## Determination 2019/066

### Regarding the refusal to issue a code compliance certificate in respect of two sides of an above-ground pool acting as the pool barrier, that were not constructed in accordance with the building consent at 8 Waiata Avenue, Remuera, Auckland

**Figure 2: The pool wall as constructed (not to scale)**

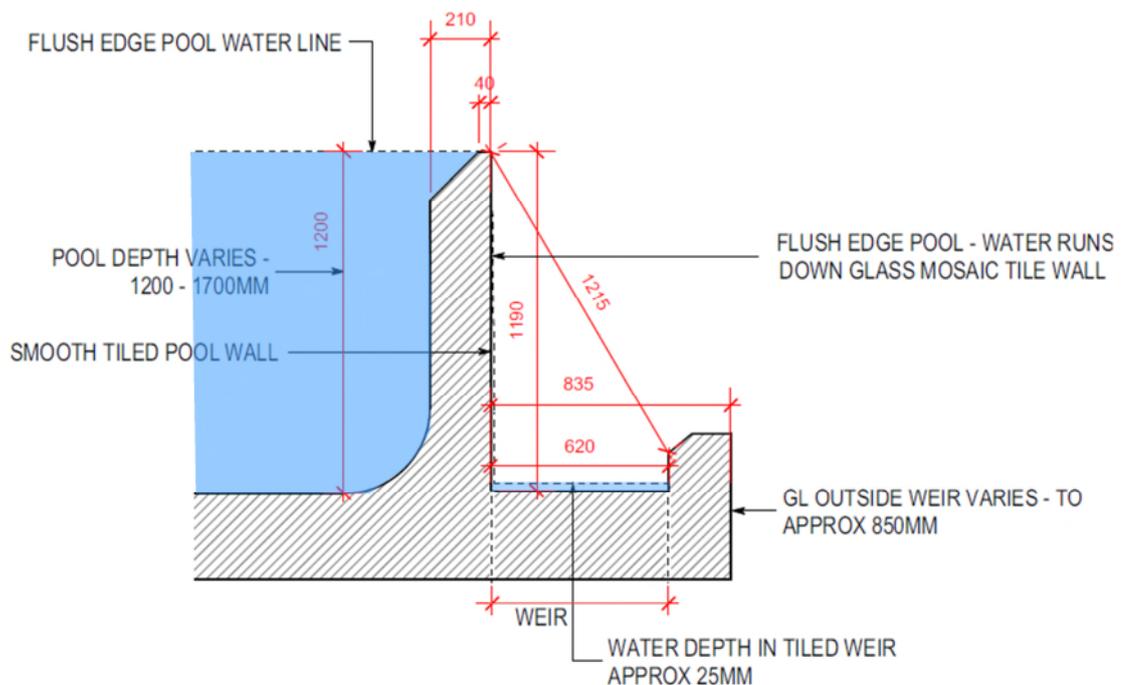
- 2.3 The top of the pool walls is 40mm wide (at the highest point), and slopes back into the pool at an angle of approximately 45 degrees. Figure 2 shows the pool wall as constructed.

- 2.4 The outer face of the pool walls are 1190mm high when measured from the bottom of the weir to the highest point of the pool walls (including the capping tiles). The internal width of the weir is 620mm. The weir wall is approximately 210mm above the bottom of the weir, and the height of the weir wall to the adjacent ground varies between 0mm to 850mm.

5.5.8 The authority noted in its final inspection (refer paragraph 3.4) the height of the pool walls to be the aspect of non-compliance. The pool walls (including the tiles) as constructed have a height of 1190mm above the bottom of the weir. This is 10mm short of the height for fences set by clause 1(1) of the Schedule, and that specified by the building consent.

5.5.9 The agent has submitted the pool walls are much "safer" than that required of the schedule because the pool walls have a greater "non-climbable surface" than the minimum requirements of the Acceptable Solution and the top edge of the pool walls are designed to prevent hand-holds.

5.5.11 The pool walls are free from any horizontal features or projections that could assist children in climbing the pool walls (the top of the pool walls and the base of the weir are 1190mm vertically apart). This is compared to the minimum 900mm required distance between any horizontal features of fences specified in the Schedule<sup>14</sup>. I agree with the agent's observation and consider this a significant feature of the pool walls in restricting access by small children. The absence of, or an increase in the

- 5.5.12 I do not consider that the top of the pool walls is constructed to “prevent hand-holds” of any kind because the configuration of the top of the wall allows for hand-hold and has no features that prevent the touching of the top of the pool walls. However, I do agree that the configuration of the top of the pool walls, the constant flow of water and the smooth tiles will result in increased difficulty for a young child in gaining a grip or hand-hold.

- 5.5.14 Furthermore, the outer surface of the pool walls is covered in smooth glass mosaic tiles, and has a constant flow of water cascading down it, providing a slippery surface. If a child were able to grip and hold the top of the wall, I consider the slippery surface of the pool walls themselves, in conjunction with the other features of the pool discussed in paragraphs 5.5.10 to 5.5.13, will make it difficult to gain enough friction to support the foothold of a child attempting to climb up.

- 5.5.15 Taking into account the combination of the particular features of the pool walls in this case, I consider the pool walls provide at least a similar performance to the fences described in the Schedule. I therefore conclude that the pool walls comply as a barrier that will restrict the access of children under 6 years of age to the pool and comply with Clause F4.3.4(f).
